Appl. No. 09/745,702
Atty. Docket No. 8384
Amdt. dated January 30, 2004
Reply to Office Action of Oct. 30, 2003
Customer No. 27752

Amendments to the Drawings:

Fig. 1

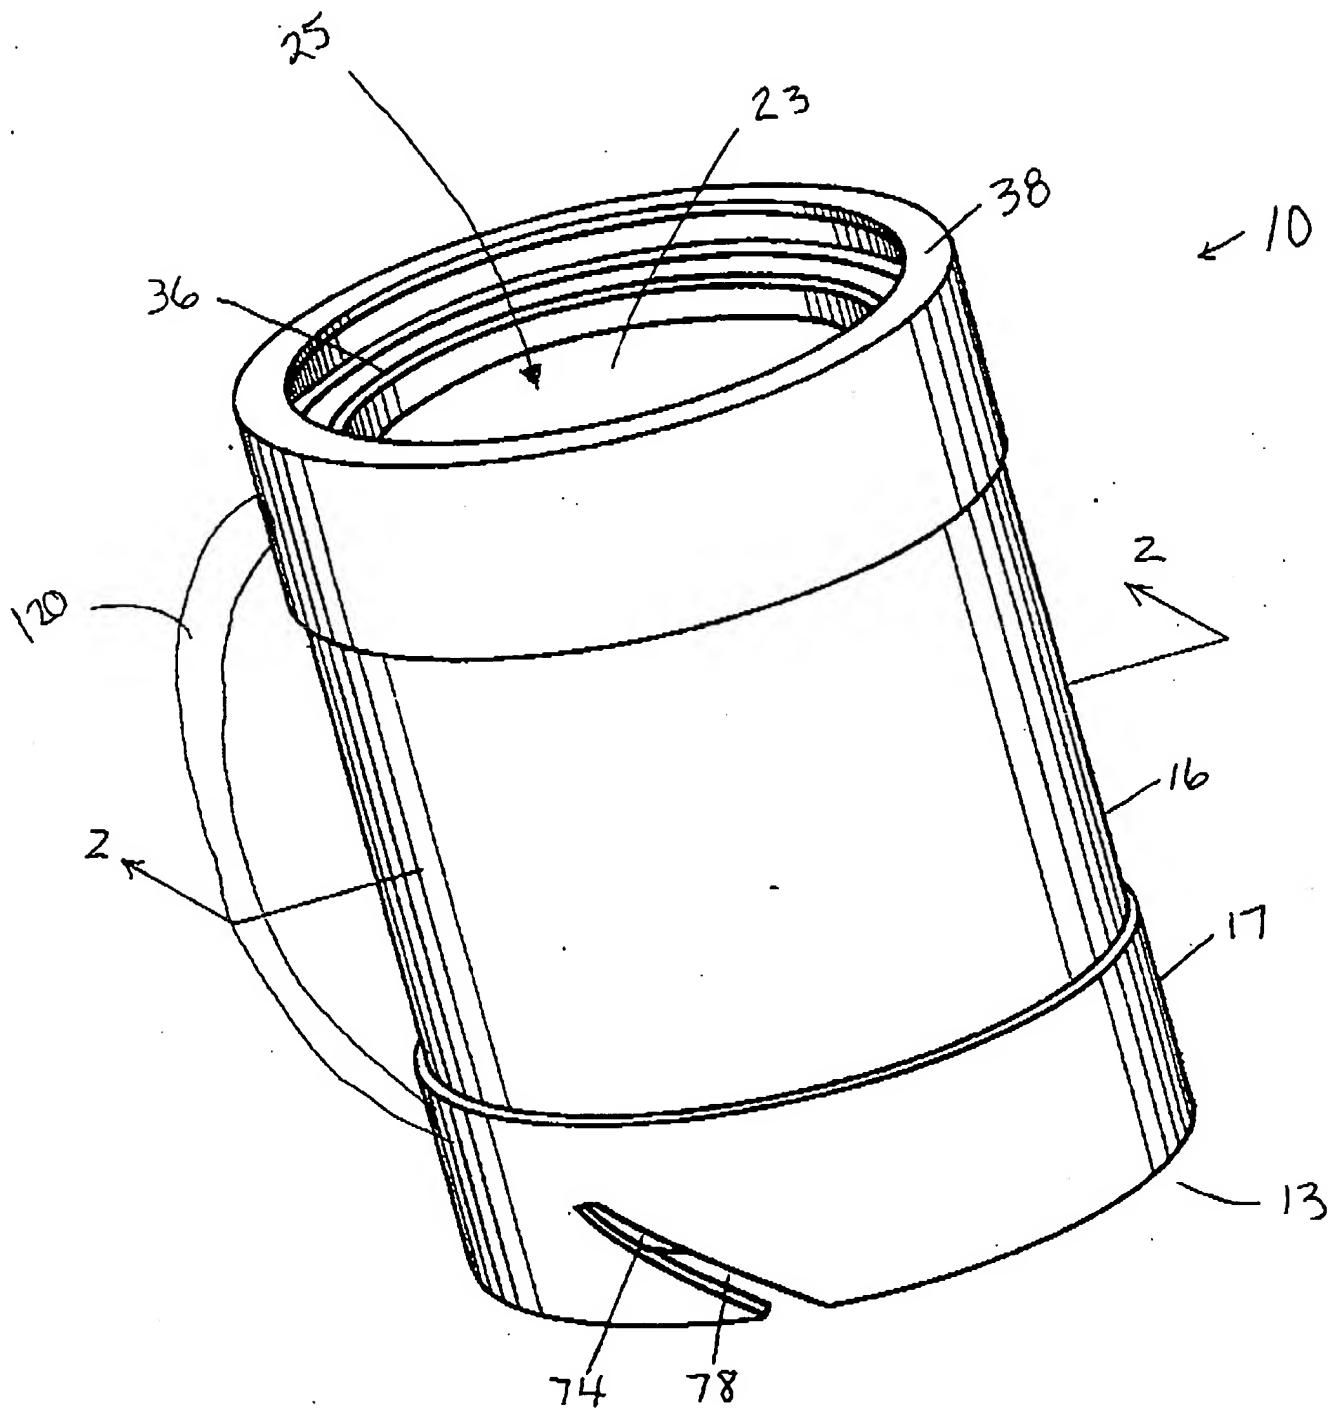
The Office Action has objected to the drawings under 37 C.F.R. § 1.83(a). The Office Action requests that the drawings show the "handle" that is claimed in claim 9, line 2. Similarly, the Office Action requests that the drawings show the "shape of the outlet opening and a portion of the passageway" being oval or elliptical in claim 10, lines 20-21.

handle 120

25 - passageway

The attached annotated sheets showing changes for Figures 1 and 3 are submitted herewith. Formal drawings will be submitted subsequent to this response.

Fig. 3

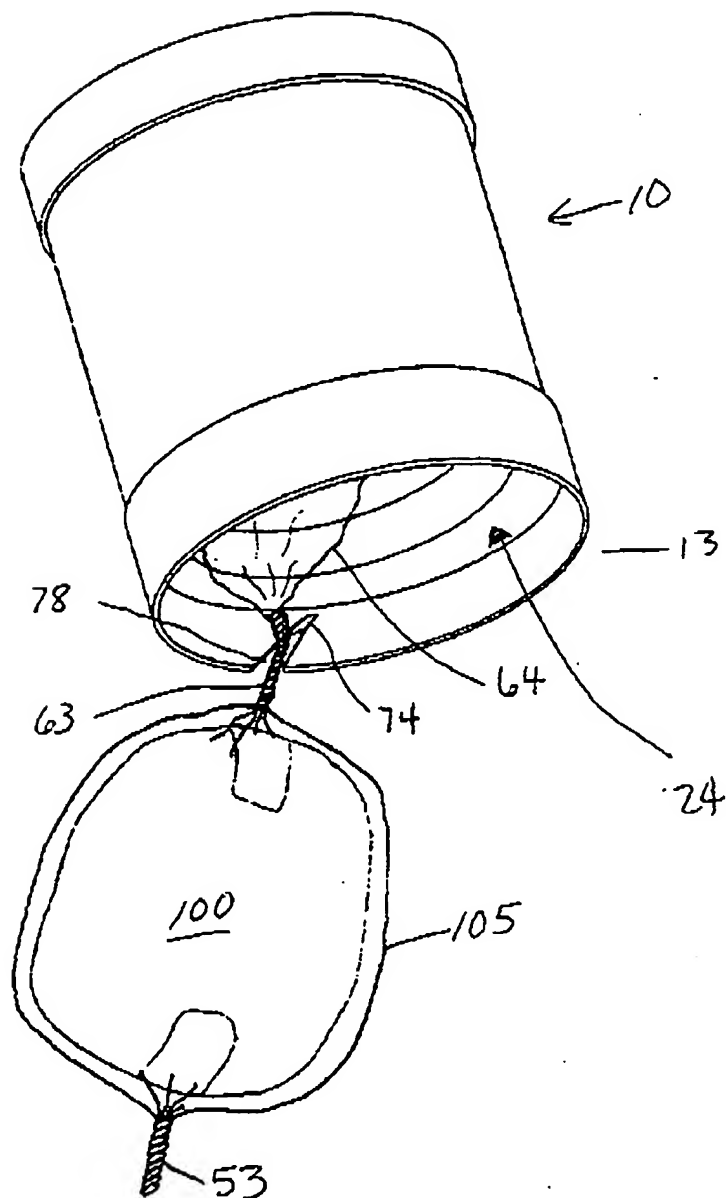
24-
outlet opening
